# A2 Bean and Ebbsfleet Junction Improvements Detailed Modification MOD-3 De-signalisation of Bean South Roundabout

Document Ref: HE543917-ATK-GEN-XX-AL-ZM-000004

**Figure 2.1: A2 Bean Junction Location Plan**

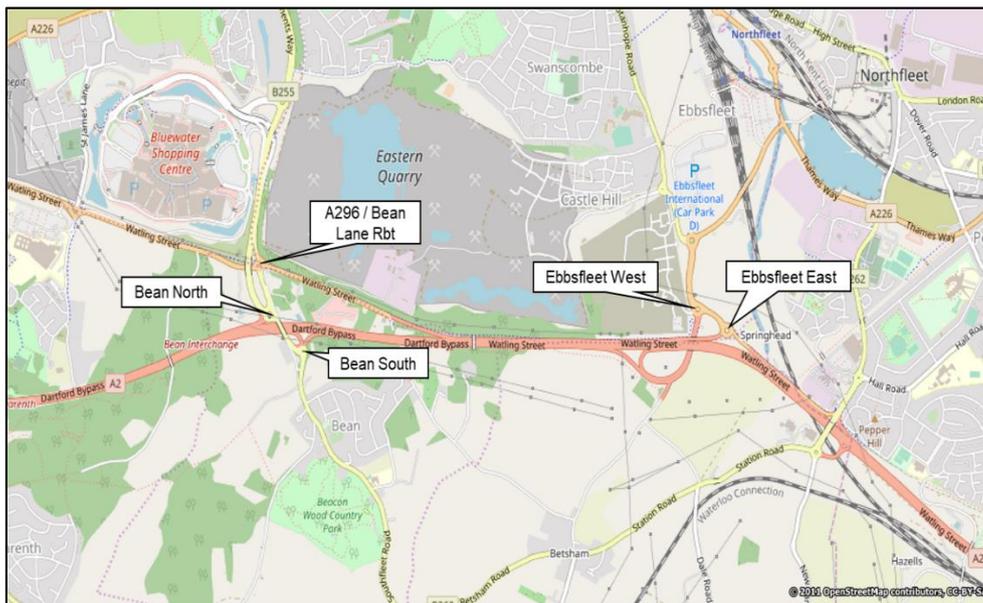
2.1.1 The Preliminary Design included for the enlargement of Bean South roundabout and the introduction of traffic signals. Whilst it is proposed to retain the overall size and lane allocation of the roundabout, consistent with the published orders, this modification removes the proposed traffic signals. The location of the Bean South roundabout in context of the overall scheme is outlined in Figure 2.1 below.
